Environment Agency permitting decisions

Bespoke Variation (Substantial)

We have decided to issue the variation for Lake District Creamery operated by The First Milk Cheese Company Limited.

The variation number is EPR/KP3931MS/V003

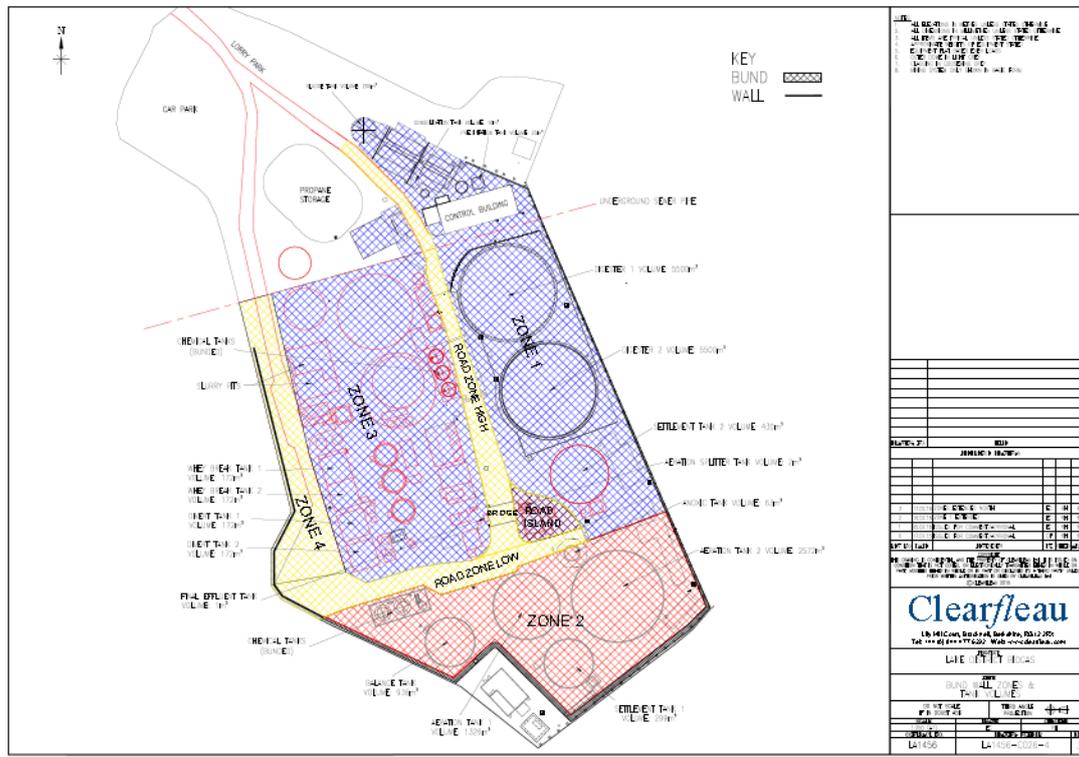
A clay bund has been installed around the lower end of the site to provide temporary containment of a significant failure of treatment plant storage (potentially up to 6050m³). This is only required for the biodegradable effluent undergoing treatment through the AD and ETP, all chemicals stored at the site have existing dedicated secondary containment.

The site operates a penstock valve which can be used to close off the discharge to the River Ellen and provide additional containment within the site boundary.

The operator recognises that whilst the current containment would only allow capture of significant spills or overtopping; it is not adequate for a catastrophic failure. Fully engineered containment will be undertaken as part of a phased programme of works which will include the removal of redundant tanks. This has been secured by the inclusion of an improvement condition.

The final containment design will provide engineered capacity to retain at least 110% of the largest vessel (i.e., an anaerobic digester at 5,770m³). A zoned approach to developing containment is proposed, focusing initially on the area associated with the AD plant, but extending to cover the remainder of the ETP as appropriate, and in line with removal of redundant plant.

More detailed drawings showing individual tanks:

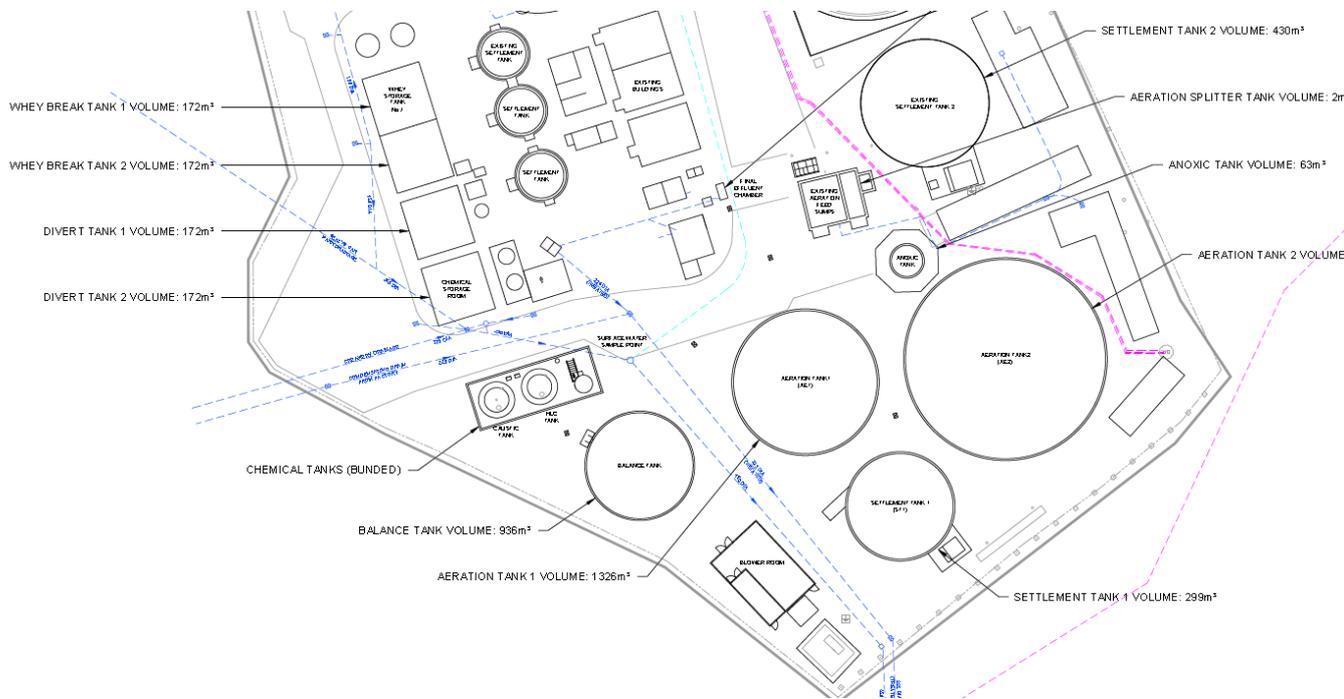
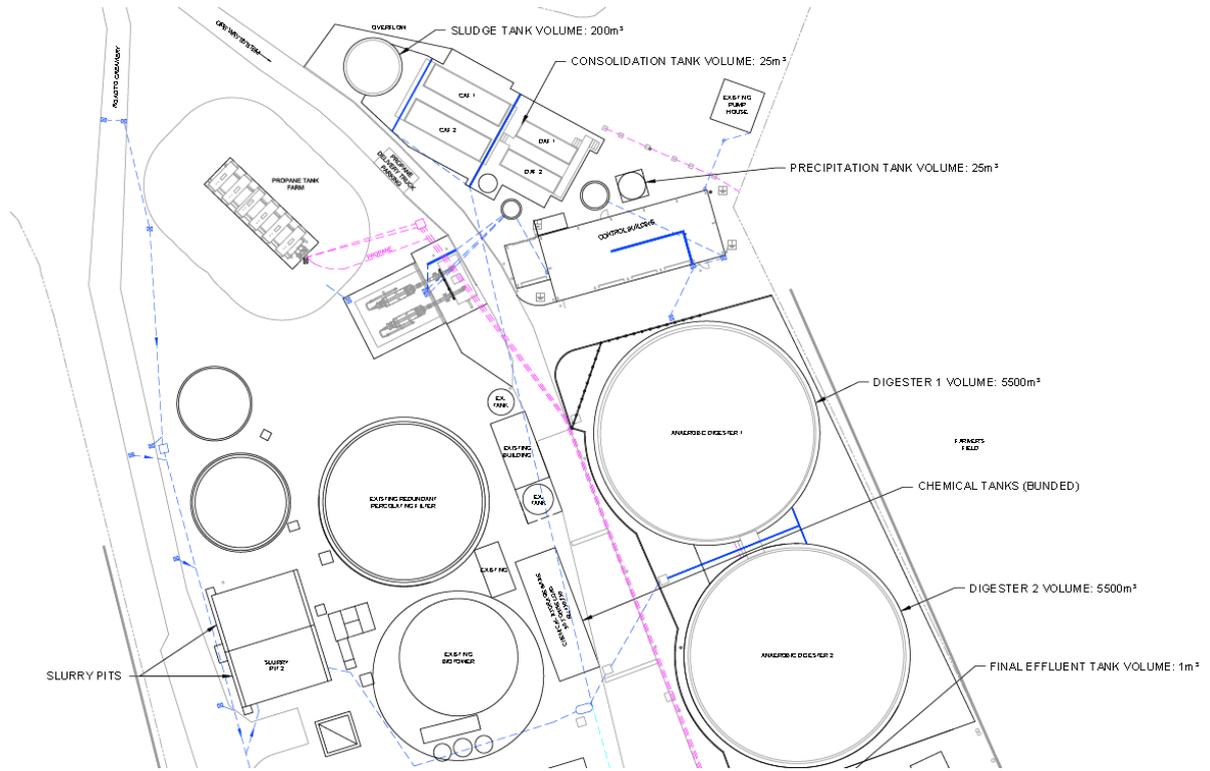
The zoning system timetable for development is as follows:

- Zone 1 (AD): end of December 2016;
- Zone 2: end of March 2017;
- Zone 3: end of June 2017;
- Zone 4: end of September 2017.

The zones are provided on drawing number LA1456-C026-4 Rev 3 (see below).

The concept design based on this approach was submitted to us 11 March 2016. Before the detailed design can be completed a comprehensive topographical survey of the site is required, together with a full survey of the existing site drainage. We have secured this by an improvement condition.
